Discussions and Replies Session 5

SESSION V

on
Failure of a Twenty-Foot High
Retaining Wall

Paper No. 5.31

Figure 1

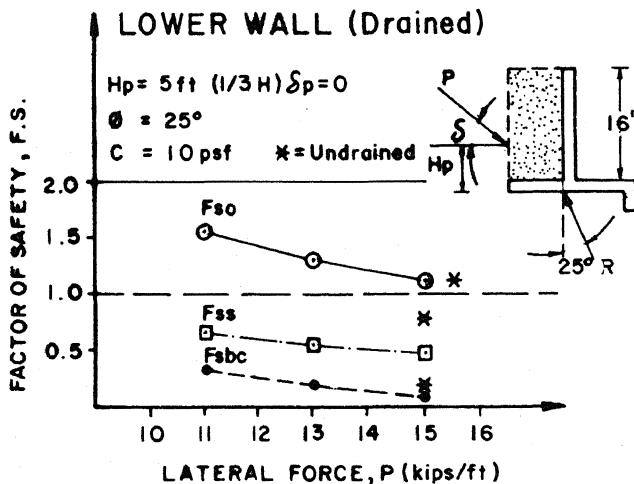
The work is valuable, well documented and comprehensive. A cross section of the site, however, showing the idealized soil profile after failure, obtained from the results of the site investigation would have been helpful. Figure 1 summarizes the results of the author's analysis in terms of safety factors for drained and undrained conditions. It is clear that the LW could not be stable from the bearing capacity and sliding points of view. It was founded on weak soil and supporting a load of about 15 kips/ft (22.4 ton/m).
